# UNITED STATES PATENT AND TRADEMARK OFFICE

APPLICATION NO.	FILING DATE	FIRST NAMED INVENTOR	ATTORNEY DOCKET NO.	CONFIRMATION NO.
10/822,659	04/13/2004	Tetsuya Miyahara	107355-00113	3143

<b>Office Action Summary</b>	<b>Application No.</b> 10/822,659	<b>Applicant(s)</b> MIYAHARA, TETSUYA	
	<b>Examiner</b> Lan Nguyen	<b>Art Unit</b> 3683

## **DETAILED ACTION**

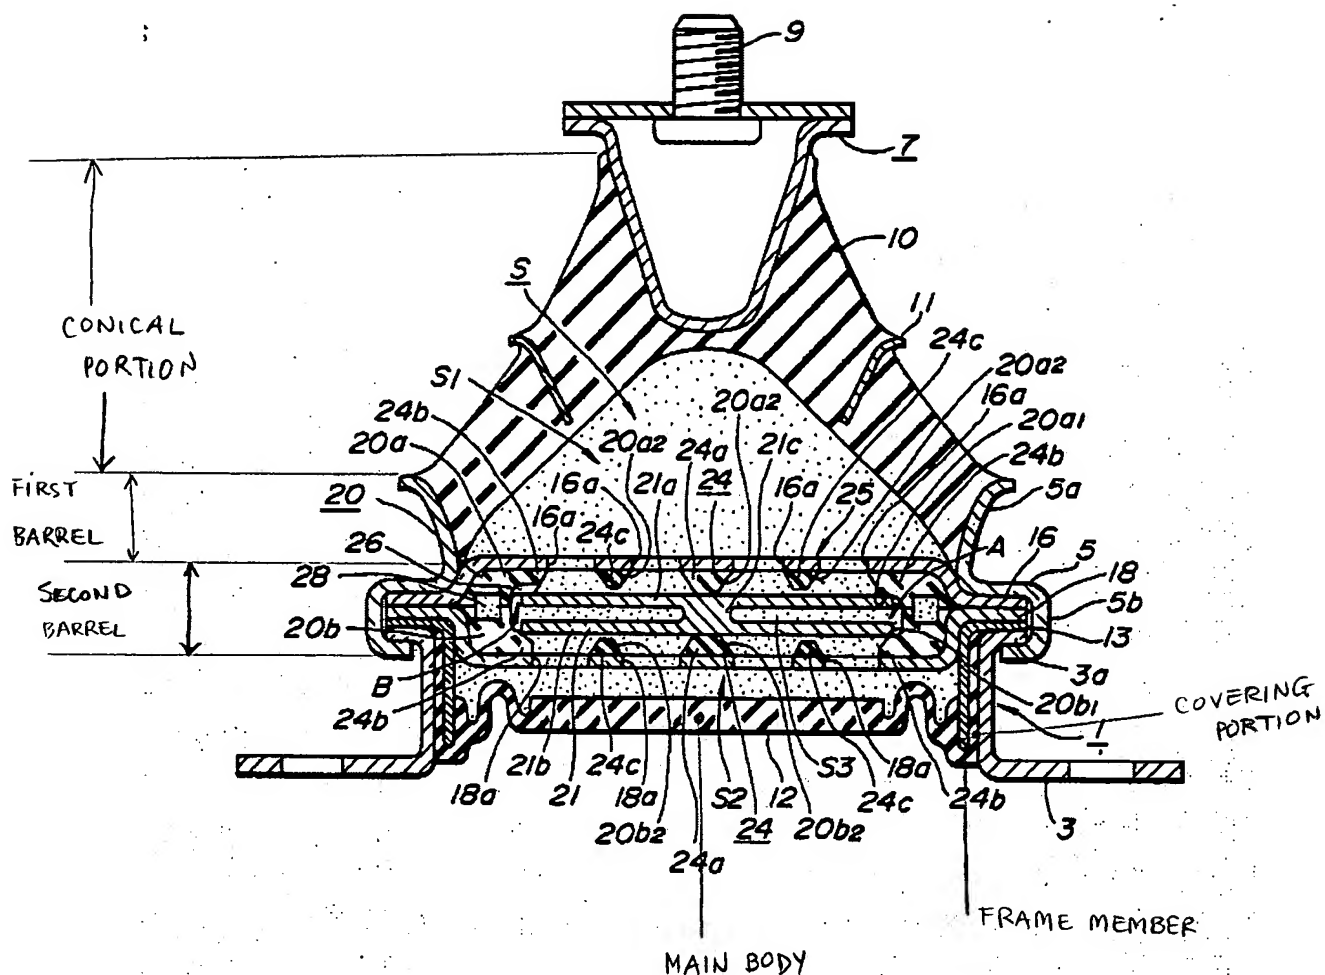
Re: claim 3, please see the marked up figure below. Note that as modified by Sprang, Miyamoto's rubber would be extending to the second barrel portion.

Re: claims 5 and 6, Miyamoto shows the diaphragm 12 comprises a frame member, a main body bonded to a first surface of the frame member, and a covering portion bonded to a second surface of the frame member wherein the covering portion defines a seal member which directly engages the metallic barrel member and the second surface of the frame member, as marked below.
